R44 SERVICE BULLETIN SB-112

DATE: 22 December 2022

SUBJECT: Tail Rotor Blade Inspection and Replacement

EFFECTIVITY: P/N C029-3 tail rotor blade S/Ns 14329 and prior (C029-3 REV Q and prior). Affected blades were factory-installed on the following aircraft:

SPECIAL TAIL ROTOR TIP PREFLIGHT INSPECTION

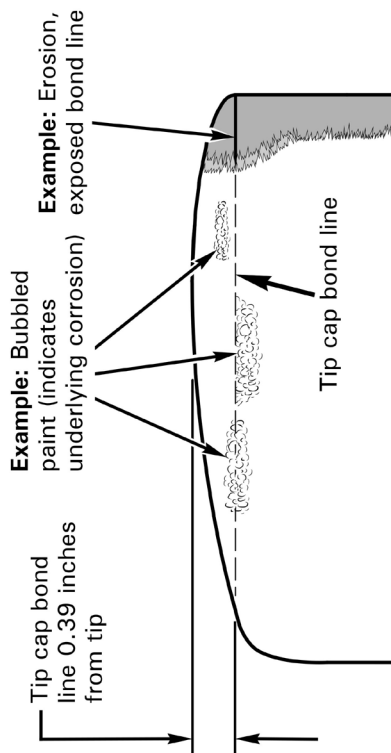
To be performed before the first flight of each day. May be performed by pilot or mechanic. Conduct visual inspection of tail rotor tip area. If bubbled paint or other evidence of corrosion is observed at or adjacent to tip cap bond line or if any portion of tip cap bond line is exposed, do not fly helicopter. Comply with latest revision of R44 SL-82 prior to further flight.
